Re: New Mexico State Police District 7 Headquarters; SIC 1542; Stormwater; Compliance Evaluation Inspection; NPDES Permit NMU001940; August 9, 2017

NPDES Compliance Inspection Report

Project: NEW MEXICO STATE POLICE, DISTRICT 7 HEADQUARTERS

NPDES Compliance Evaluation Inspection NPDES Permit NMU001940 August 9, 2017

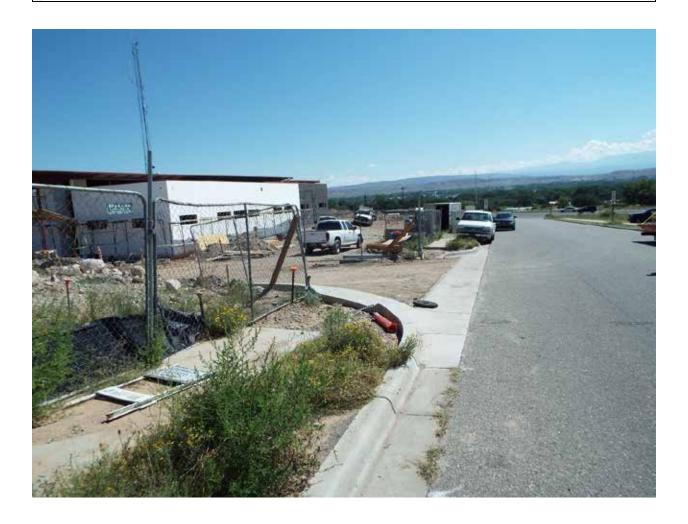
Subject: On of two entrances on site. (southwest entrance) Part 2.2.4/Permit

Requirements: Use appropriate stabilization techniques (e.g., use of aggregate stone with an underlying geotextile or non-woven filter fabric, and turf mats) at **all points that exit onto**

paved roads.
